TECHNICAL BULLETIN 015

FIAT 1.9 JTD ENGINES / ACCESSORY DRIVE / BELT INFO

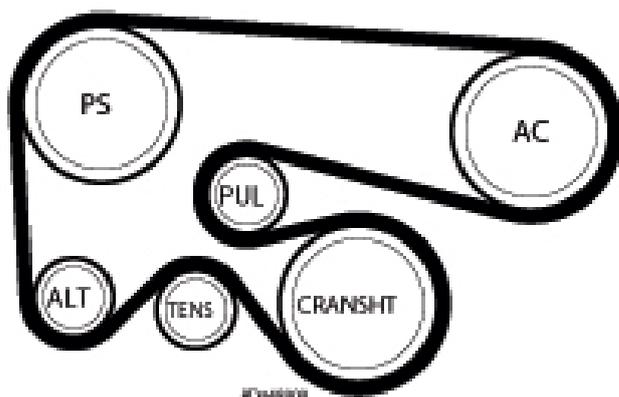
On different models from the Fiat group, equipped with the 1.9 JTD engine and air conditioning compressor in the drive, several adjustments have been made to the accessory drive system since its introduction.

Belt length, tensioner and pulleys have undergone small changes for continuous improvement on the drive performance.

As a result, the Fiat group now only offers 1 belt size for this drive:

This means that the 6PK1840, previously recommended for some of these applications, should no longer be installed on this 1.9 JTD + AC drive. For correct actual applications, please check our online catalogue.

The OE/OES references are 55189679 and 71734476.

The Gates Micro-V® replacement belt is **6PK1835XQ**.
